ITB ADDENDUM NO. 2
2023 City Wide Asphalt Repair
PUBLICS WORKS PROJECT NO. PW2023-003

Date Published: 3/24/2023
Date of Addendum #2: 4/14/2023
Date of Bid Opening: April 19th, 2023

Schedule E- Decant Facility

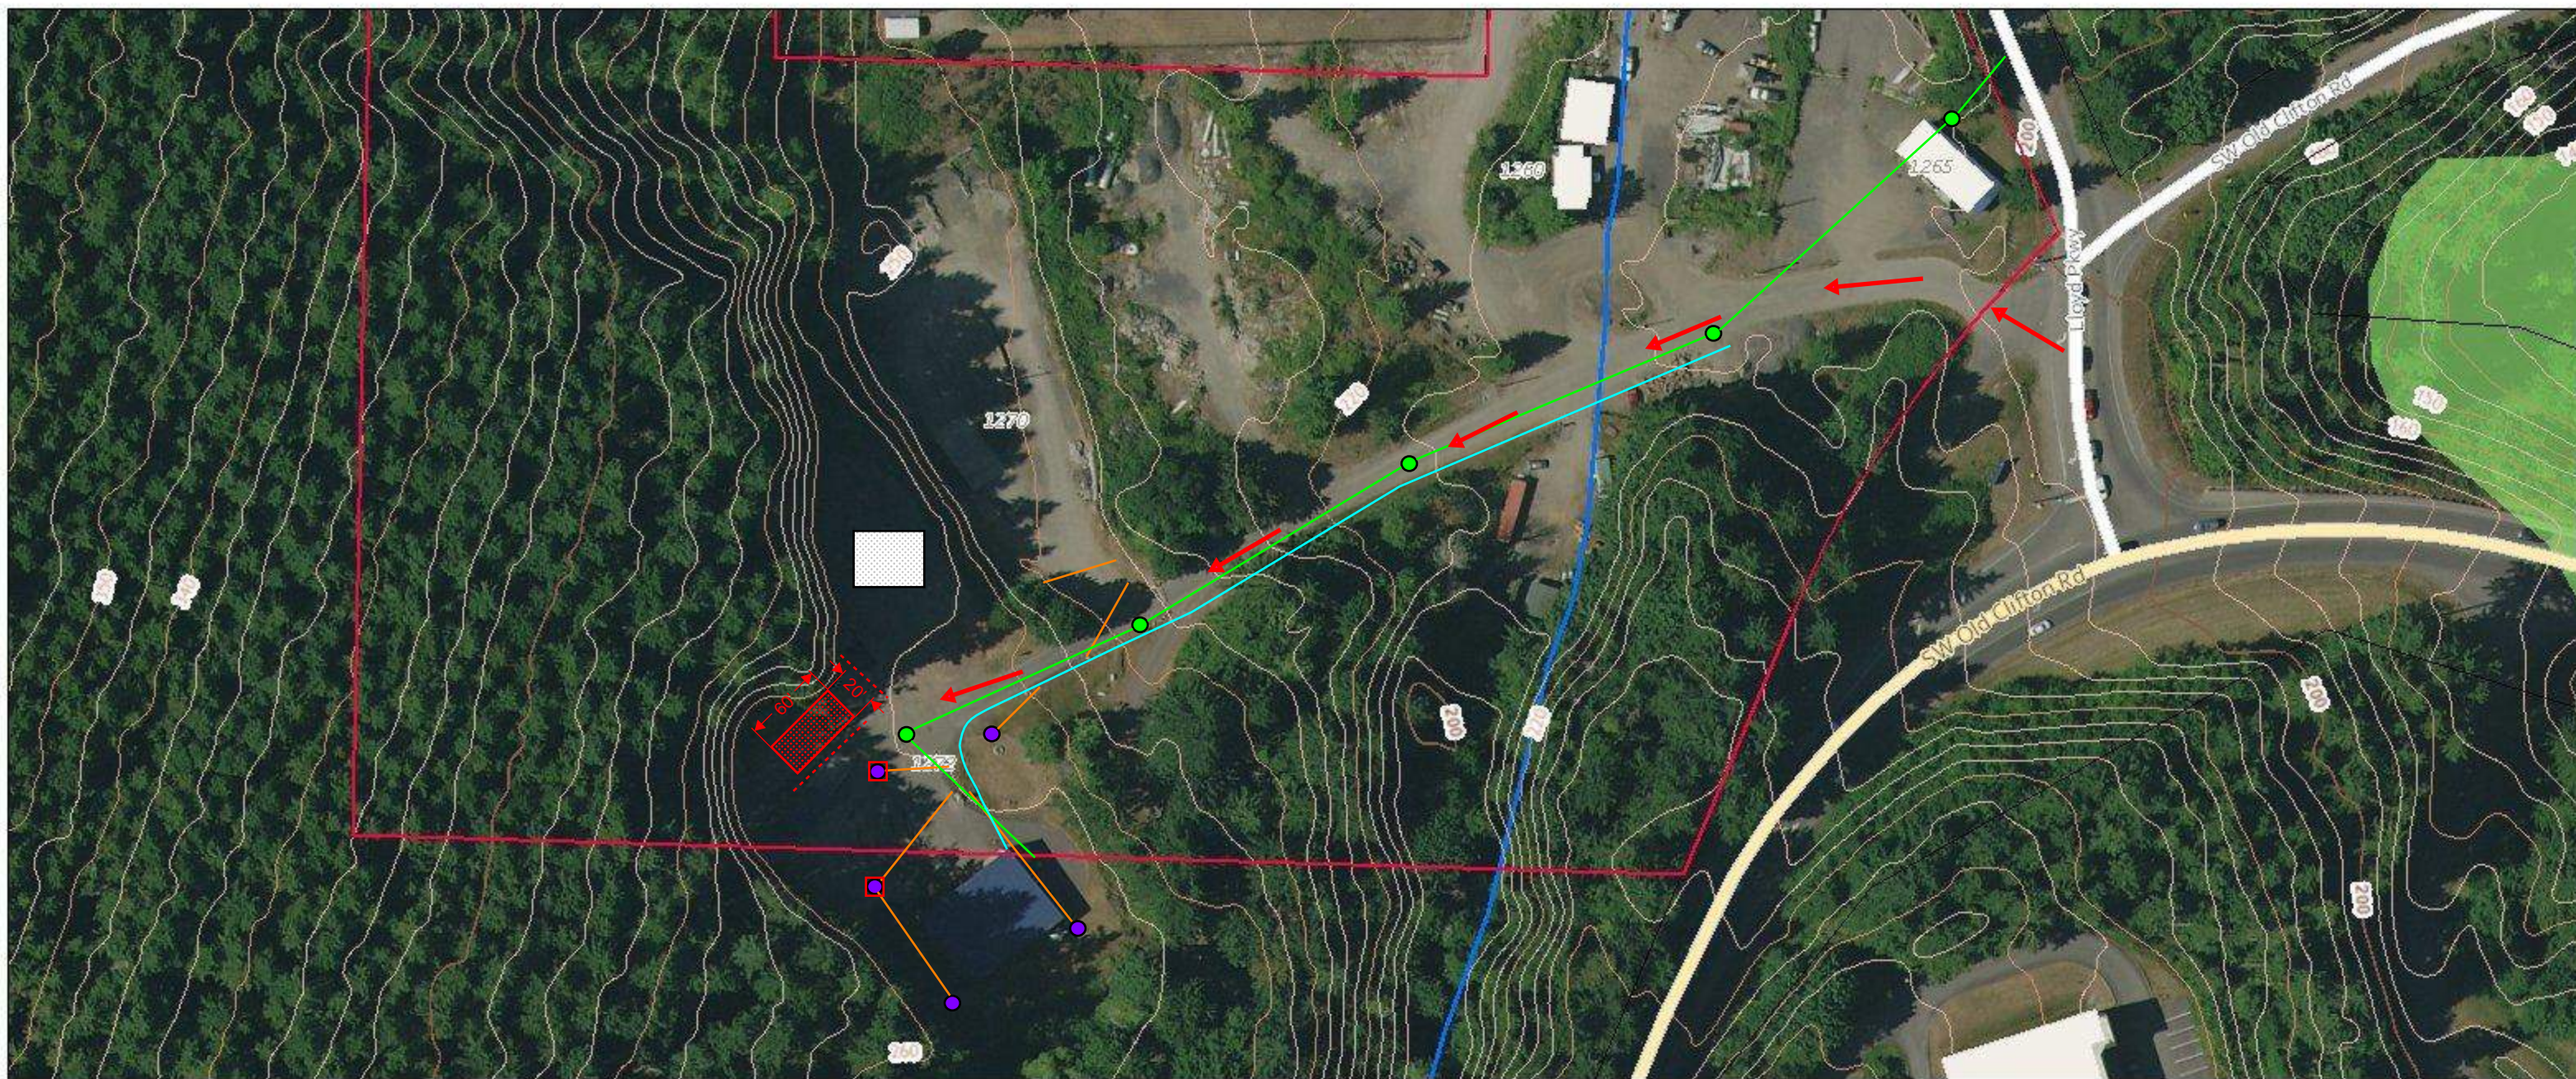
Question 5: (Schedule E- Decant Facility) Can additional information be provided regarding location and prep work needed?

Answer 5: Yes, see Decant Site Plan below. Grading and Base in preparation for asphalt by others.
